UNITED STATES
DEPARTMENT OF THE INTERIOR
BUREAU OF LAND MANAGEMENT
APPLICATION FOR PERMIT TO DRILL OR REENTER

1a. Type of work: <input checked="" type="checkbox"/> DRILL <input type="checkbox"/> REENTER 1b. Type of Well: <input checked="" type="checkbox"/> Oil Well <input type="checkbox"/> Gas Well <input type="checkbox"/> Other 1c. Type of Completion: <input type="checkbox"/> Hydraulic Fracturing <input checked="" type="checkbox"/> Single Zone <input type="checkbox"/> Multiple Zone		5. Lease Serial No. NMNM102917 6. If Indian, Allottee or Tribe Name 7. If Unit or CA Agreement, Name and No. 8. Lease Name and Well No. CASEY JONES 21 FED COM 712H 9. API Well No. 30-015-54126

Casey Jones 21 Fed Com 712H

Casey Jones 21 Fed Com 712H

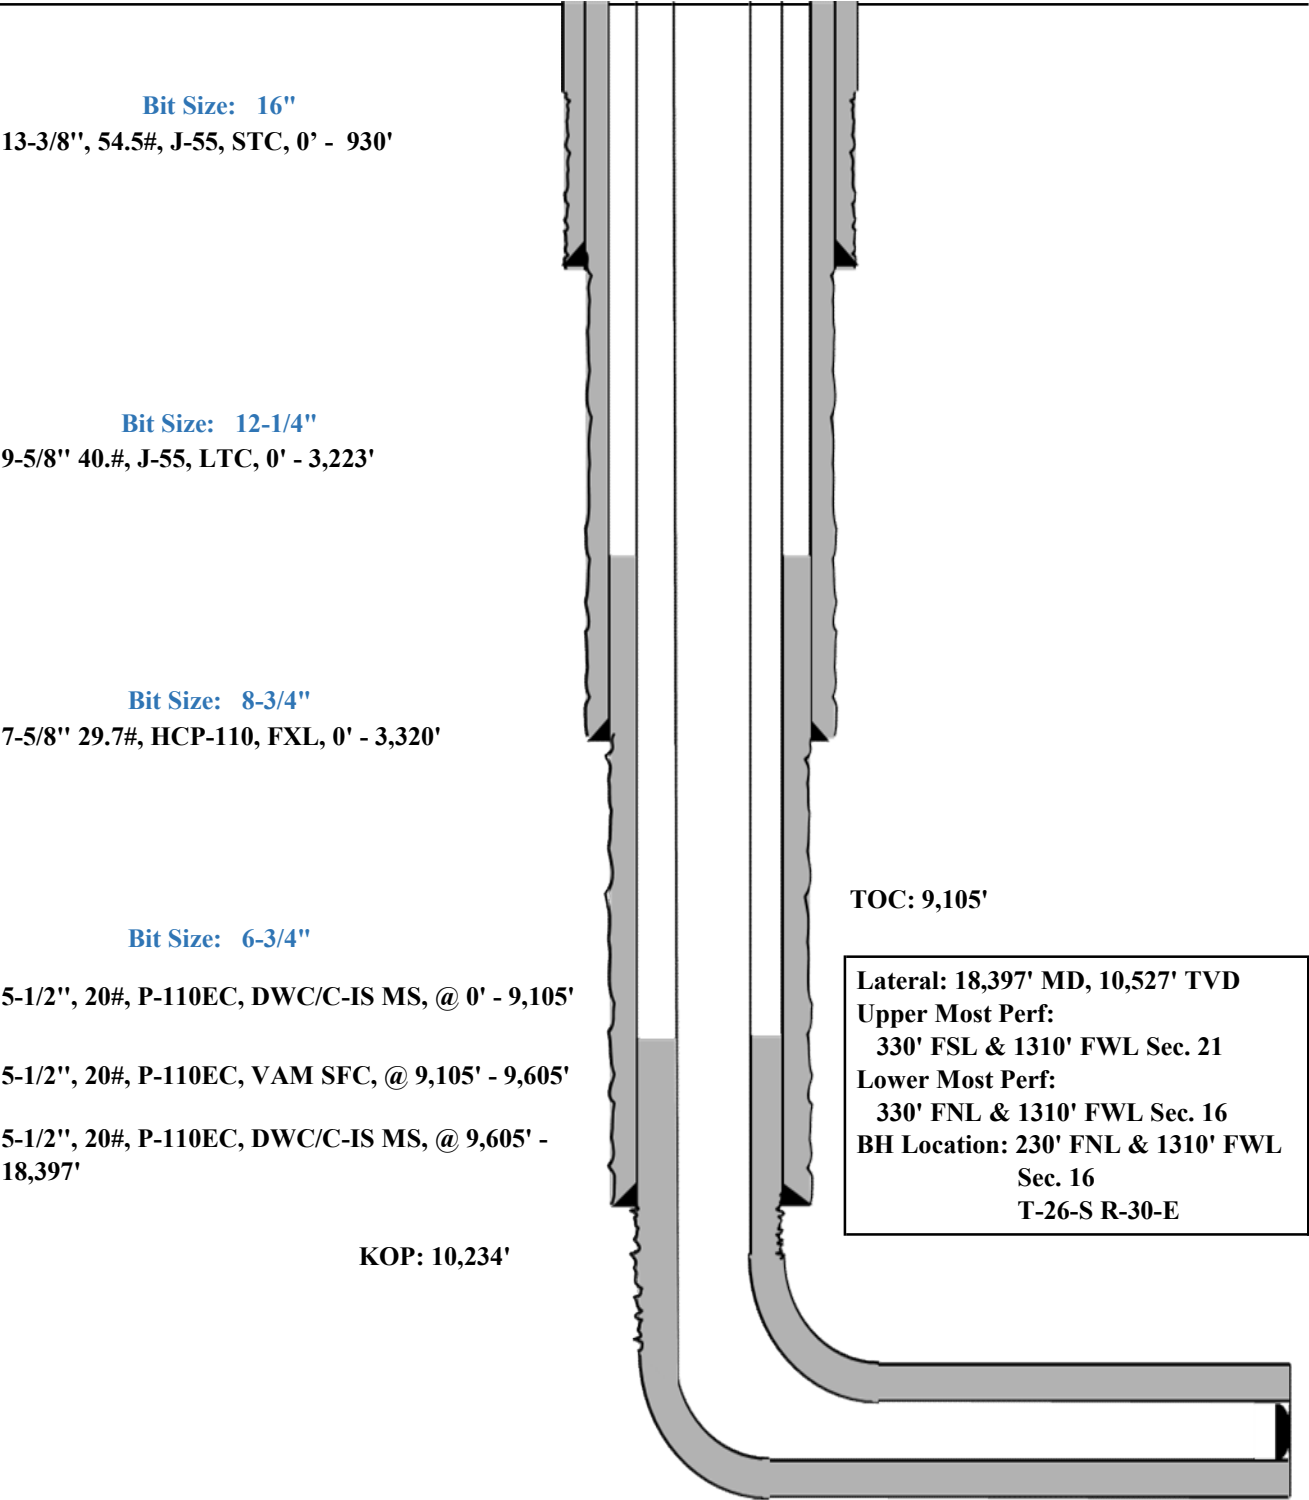
Operator is only approved for Design A. Design B is not to be utilized. If Design B is needed or any other change, please submit a NOI sundry to make the changes.

Operator has proposed to pump down 9-5/8" X 7-5/8" annulus after primary cementing stage. Operator must run Echo-meter to verify Cement Slurry/Fluid top in the annulus Or operator shall run a CBL from TD of the 7-5/8" casing to surface after the second stage BH to verify TOC.

3. The minimum required fill of cement behind the **5-1/2** inch production casing is:
 - Cement should tie-back at least **200 feet** into previous casing string due to operator not meeting casing clearance requirement per 43 CFR 3170. Operator shall provide method of verification.
